INTERSTATE ROUTE H-2 HOV LANES, PHASE I
WAIPIO TO WAIAWA INTERCHANGE
Project No. IR-H2-1(26)

STATE OF HAWAII DEPARTMENT OF TRANSPORTATION HIGHWAYS DIVISION	
RETAINING WALL PLAN AND ELEVATION	
I.B. STA. 375+00 TO STA. 376+97	
I.B. STA. 403+75 TO STA. 406+00	
INTERSTATE ROUTE H-2, HOV LANES, PHASE I	
WAIPIO INTERCHANGE TO WAIPILO INTERCHANGE	
Project No. IR-H2-11(26)	
Scale: As Noted	Date: Jan. 1991
SHEET No. S2 OF 20 SHEETS

"AS-BUILT"

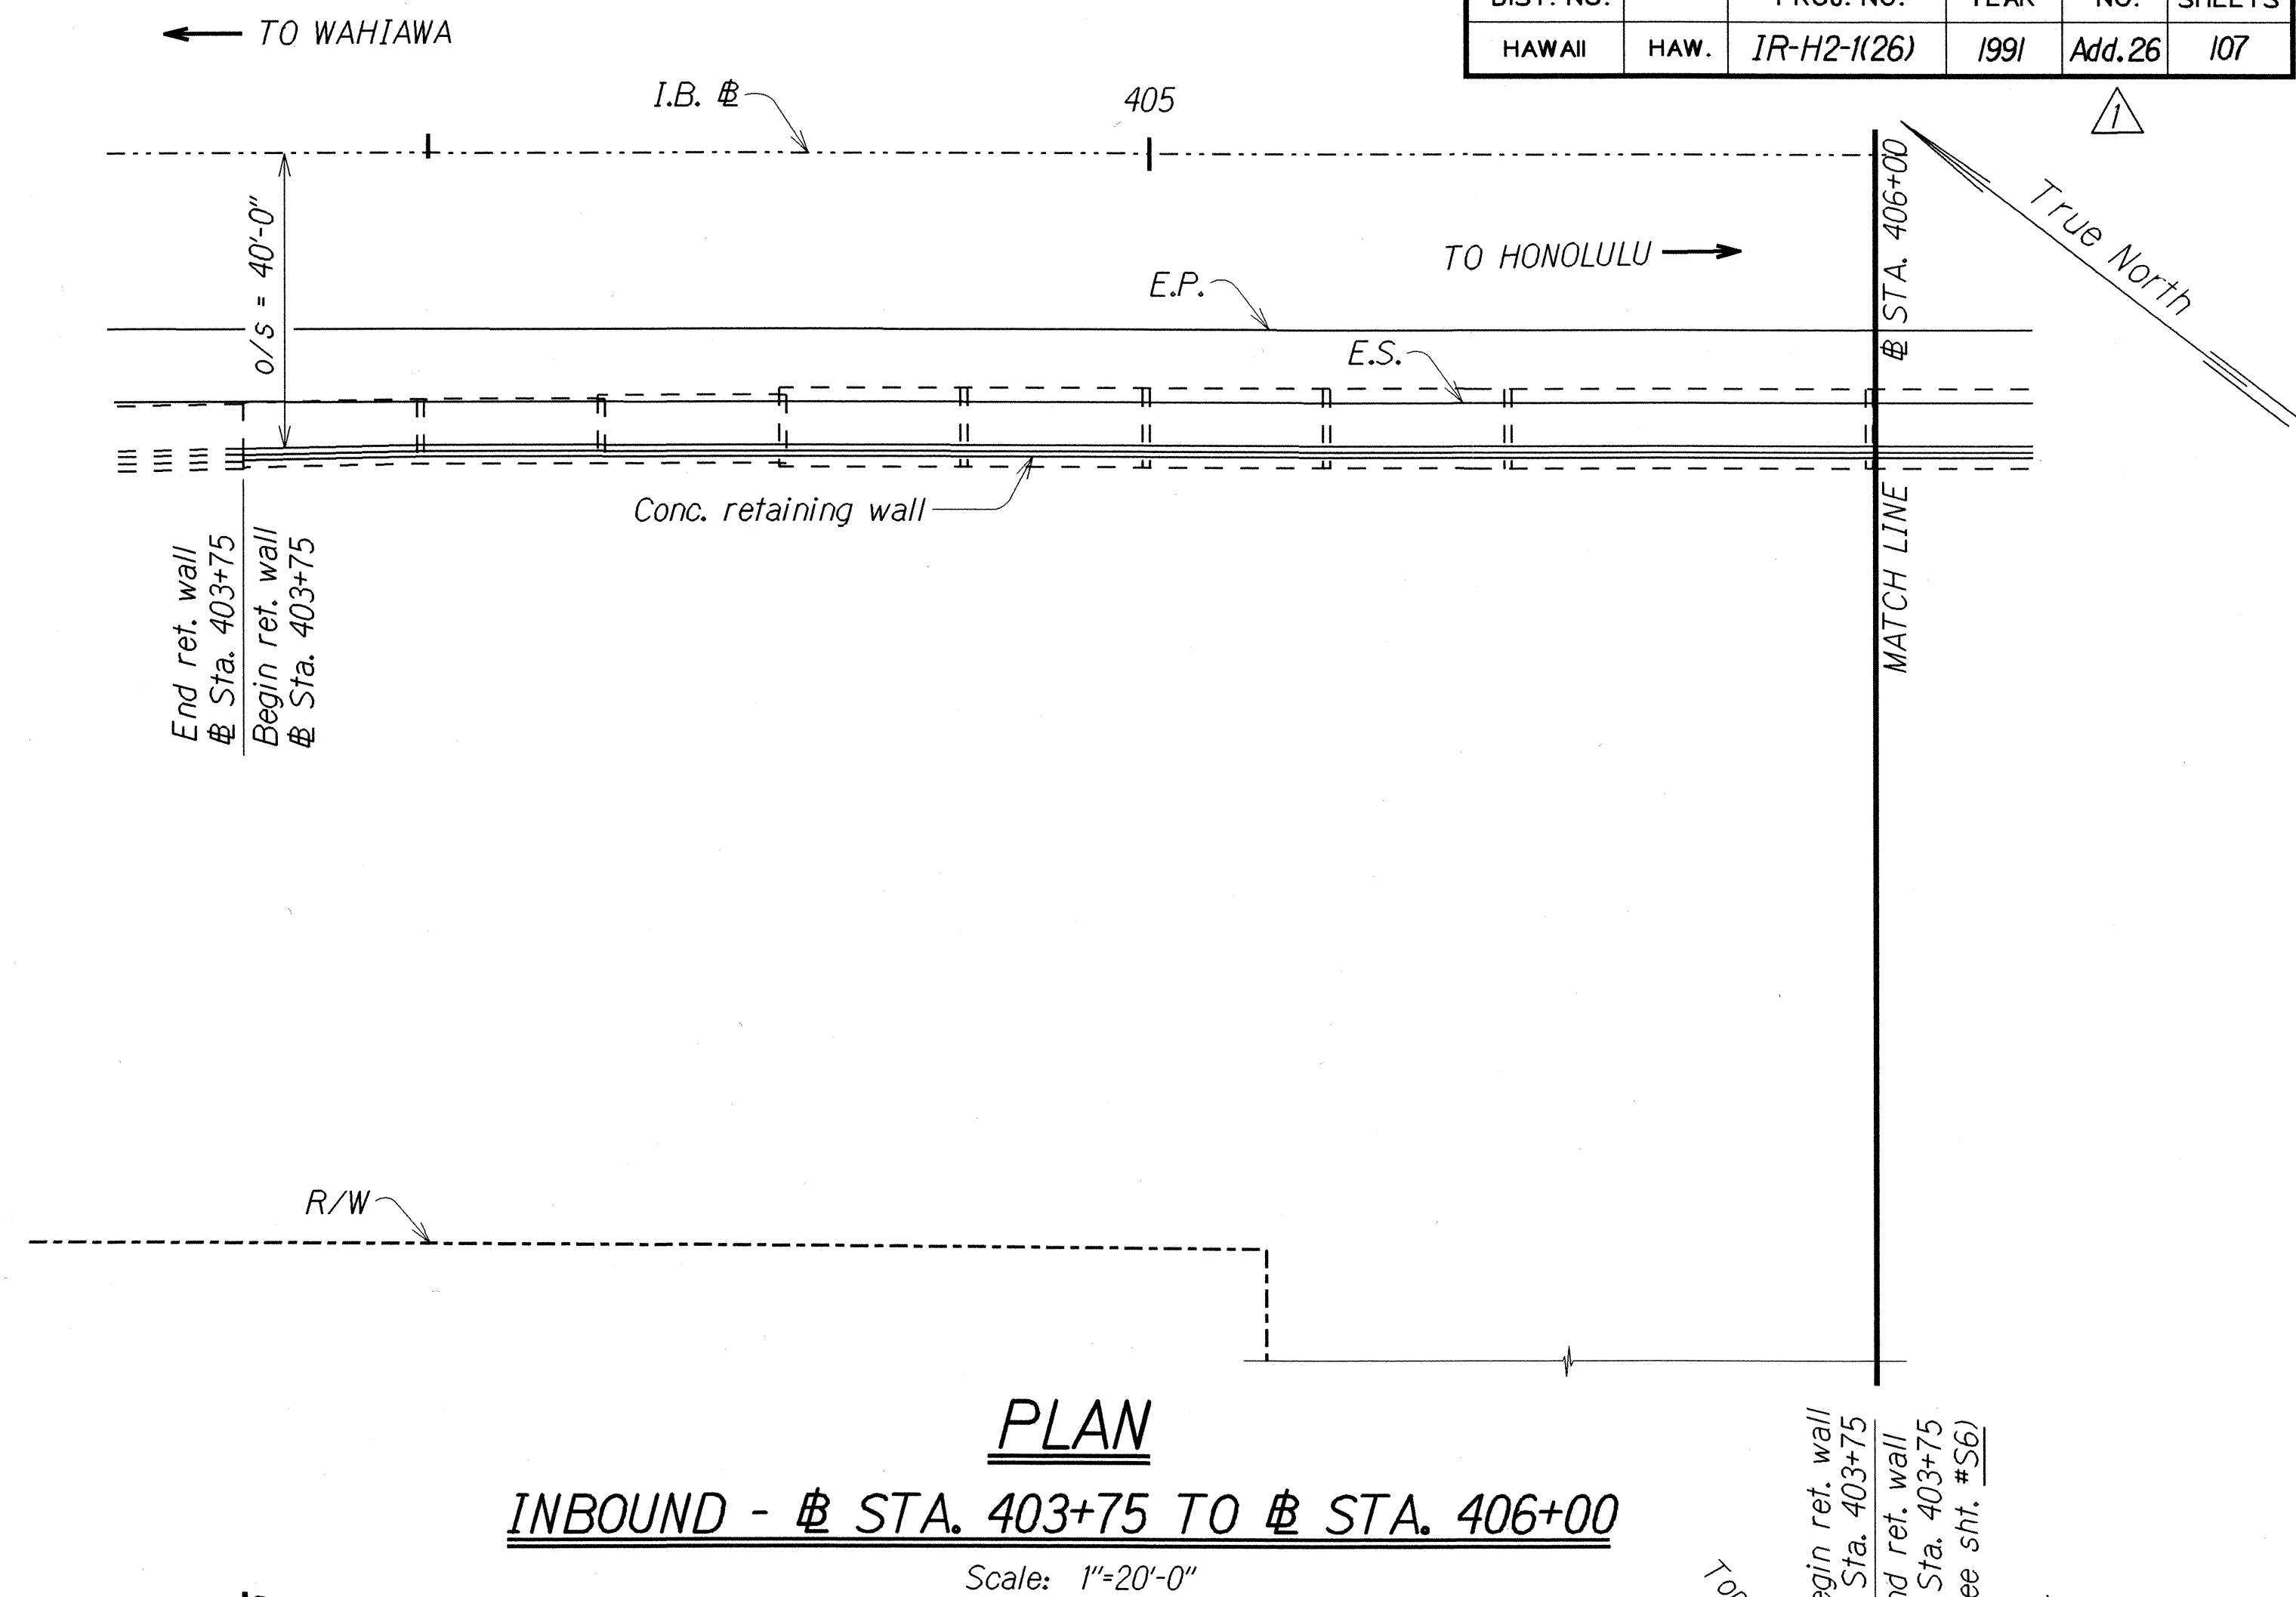
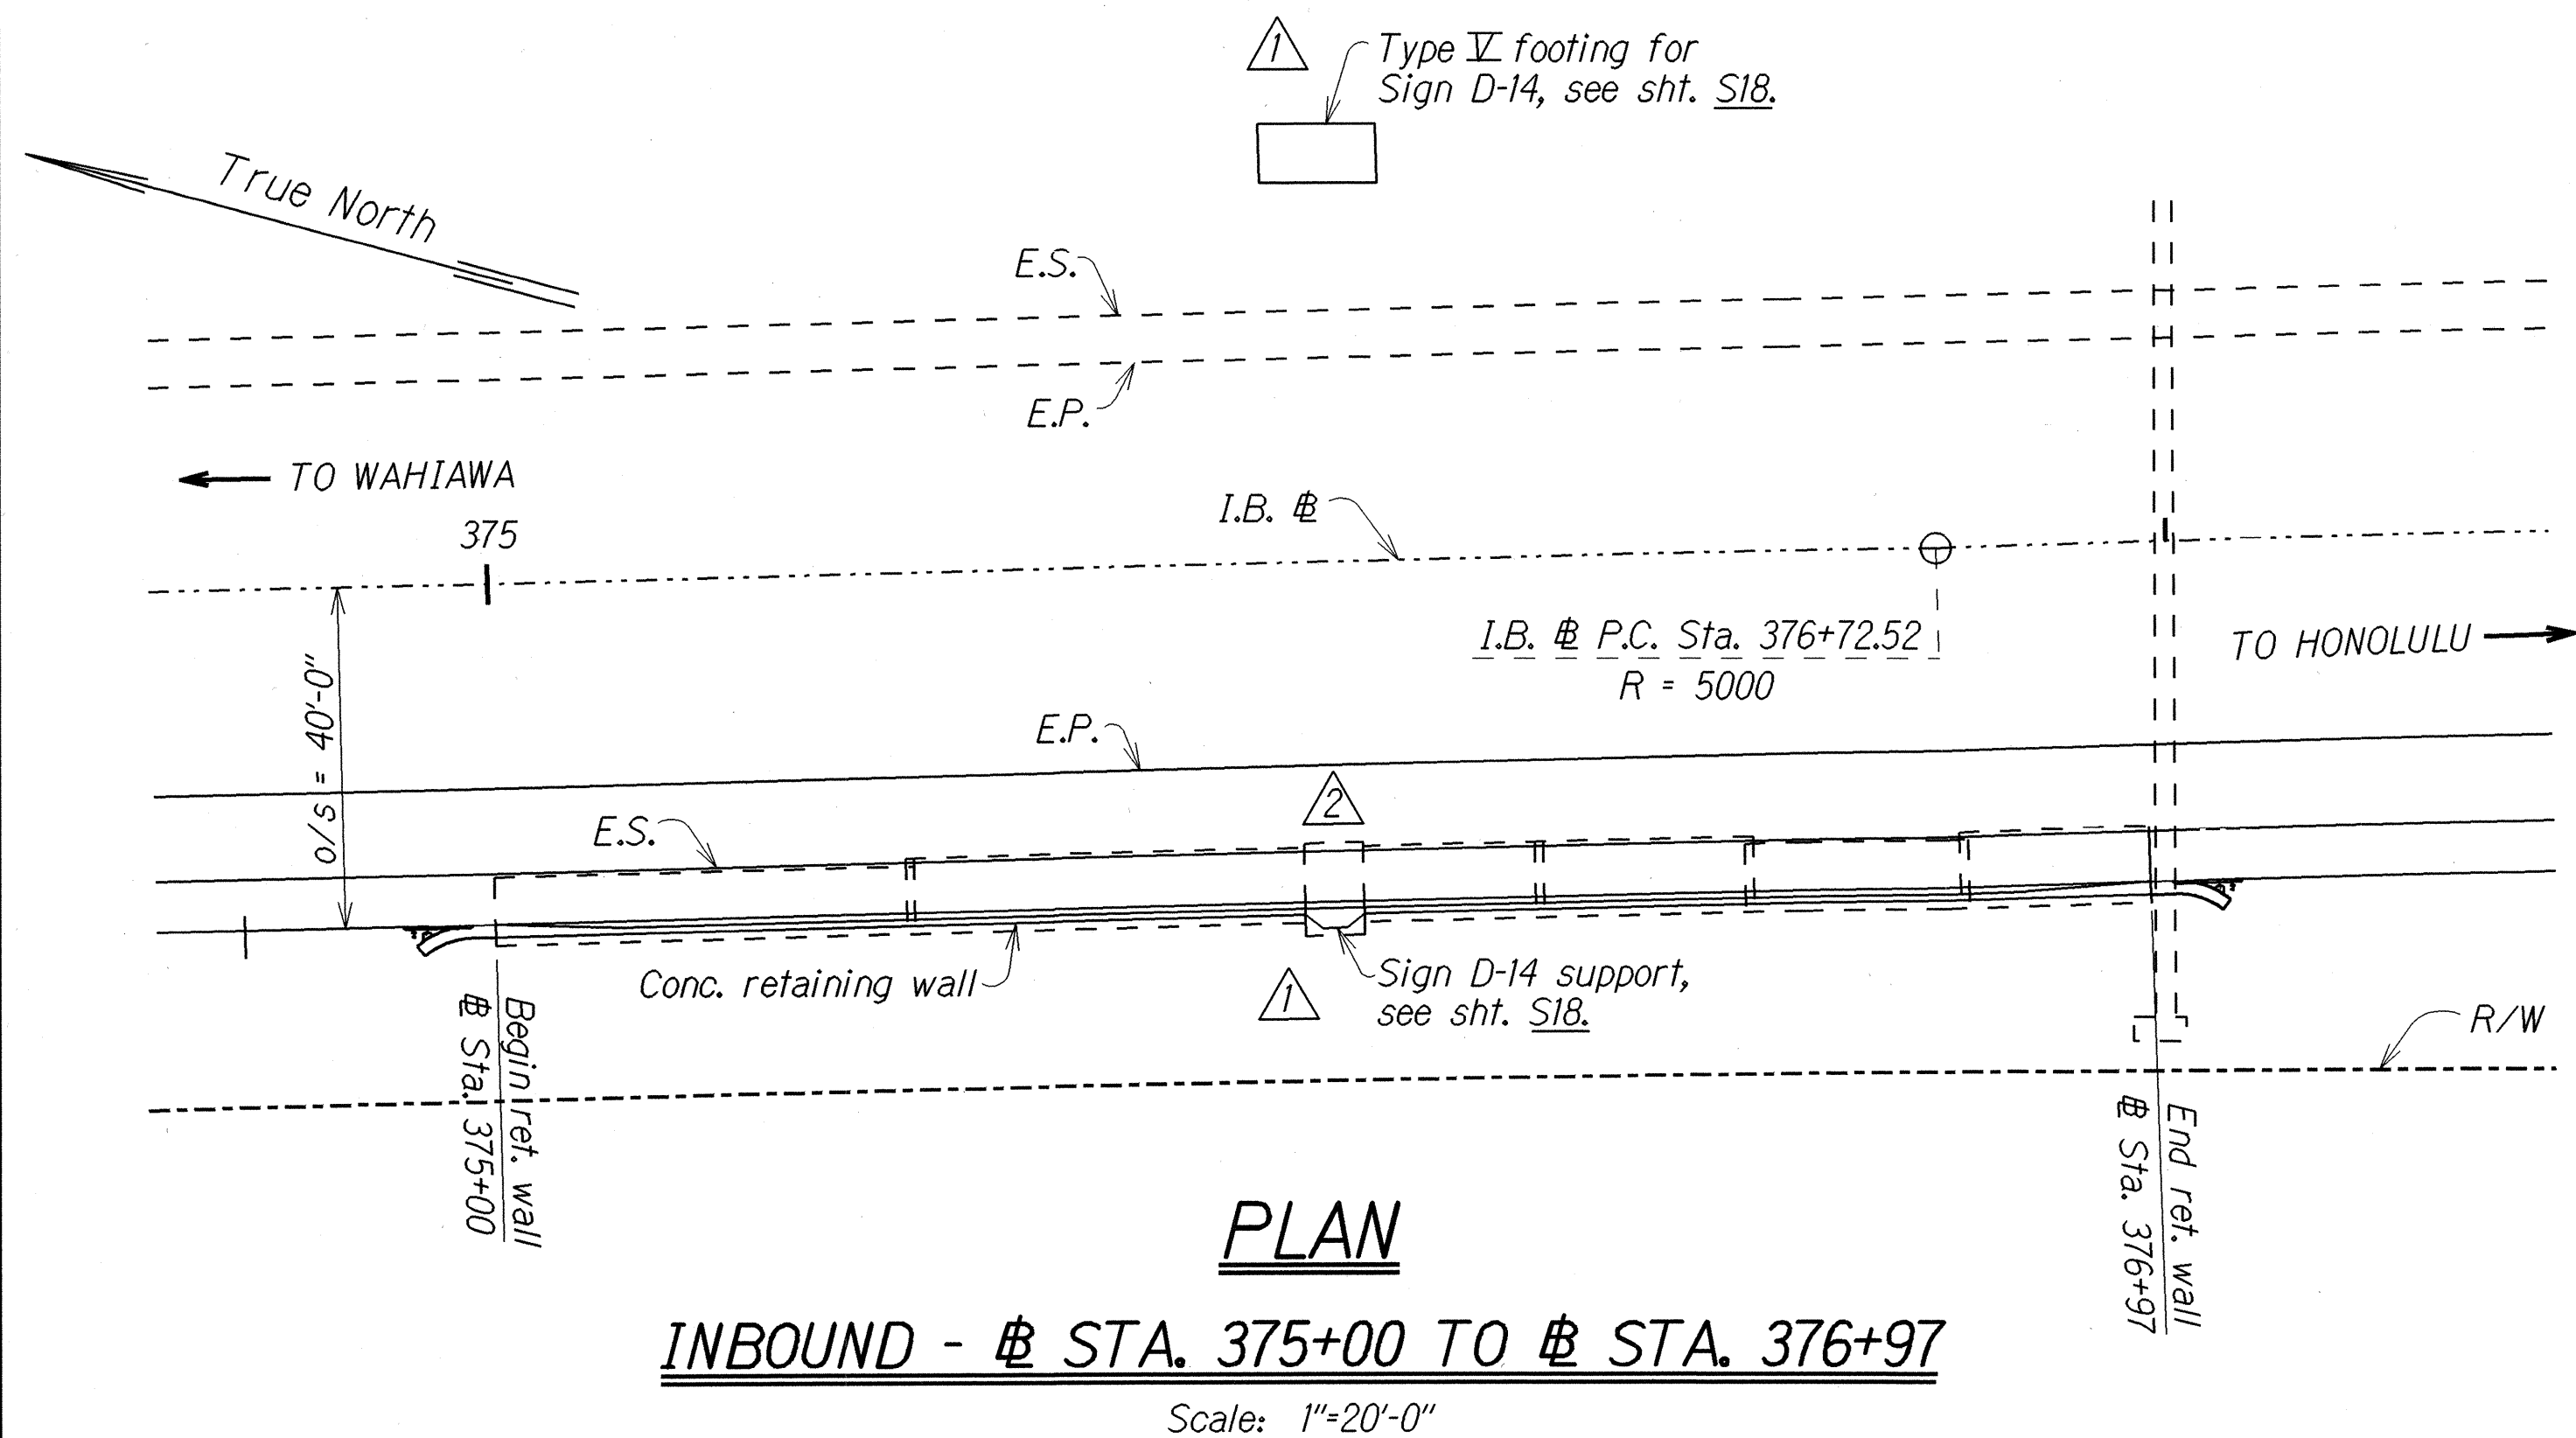
1/14/92	Footing extended.	5/15/91	Sheet added to Contract Plan set for additional details required on sht. no. ADD. 26, per Addendum No. 1.
DATE	REVISION	DATE	REVISION
